CALIFORNIA COASTAL COMMISSION

STAFF REPORT: REGULAR CALENDAR

APPLICATION NO.: 4-95-162

PROJECT DESCRIPTION: Construction of a 72 foot long 4.5 foot high concrete retaining wall at the base of a slope in Ramirez Creek, with backfilling of the slope between the retaining wall and Ramirez Canyon Road.

Exhibit 6: Wall Plan in creek
4-95-162

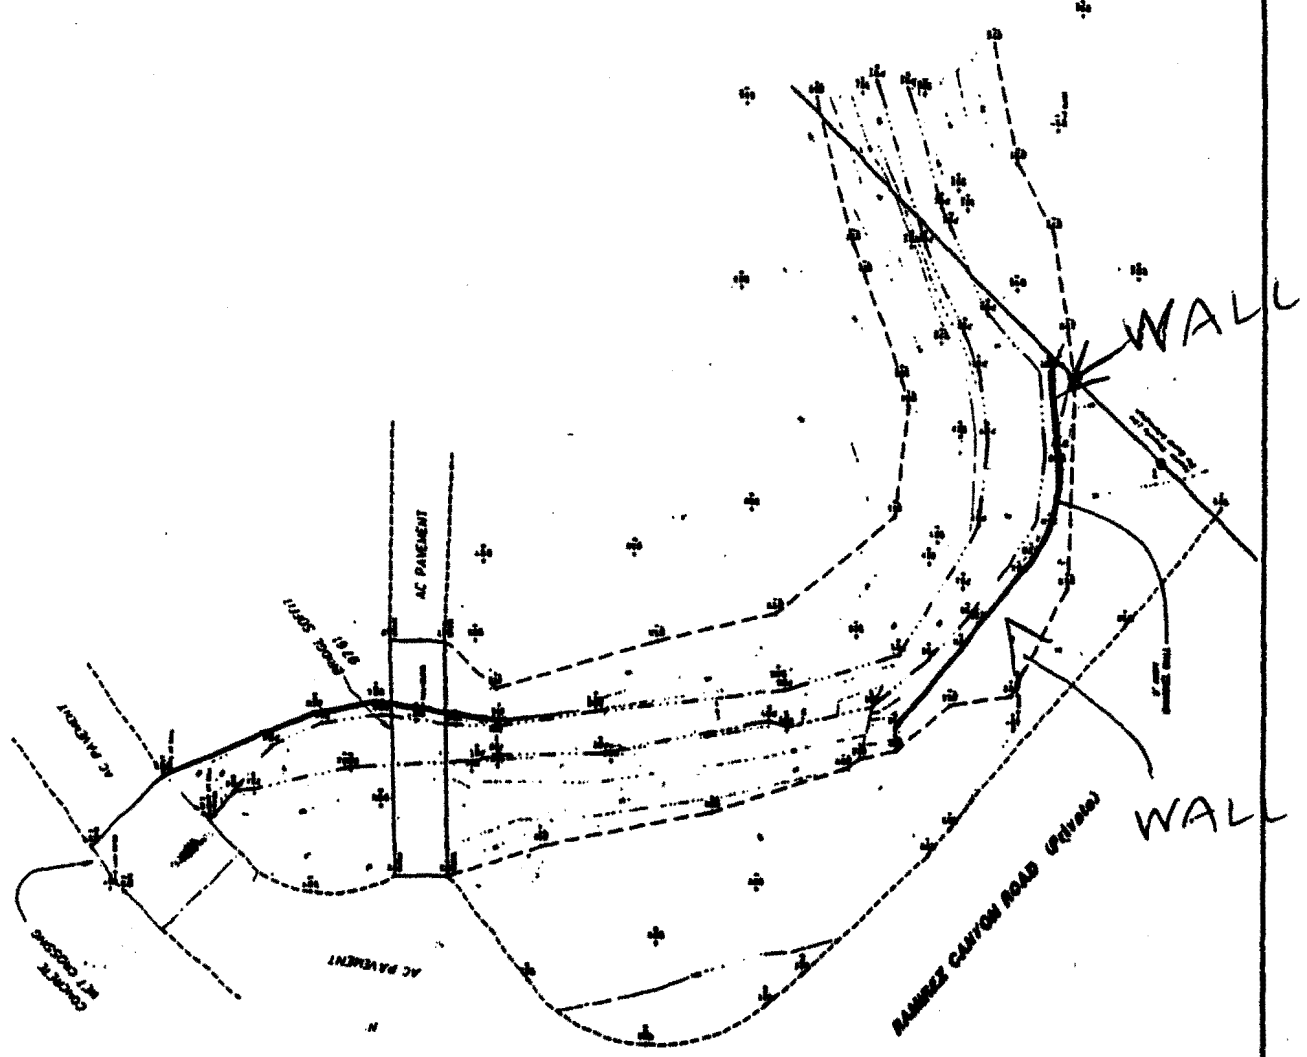
The proposed wall is located in the creek between the center line of the stream and the road which is at the top of the bank. According to the drawings submitted by the applicant (Exhibits 6 and 7) the wall is not located within the streambed but rather where the bank used to be. In fact, the cross-section shows that the wall is set slightly back for the original toe of the bank but is still within the streambed. The streambed is the area where the water flows. As stated previously, streams meander through a larger floodplain, widening and narrowing, and turning at different places over time, which in turn changes the location of the streambed. Water flow in this channel occurred where the wall is now located, and thus the wall is located within the streambed.
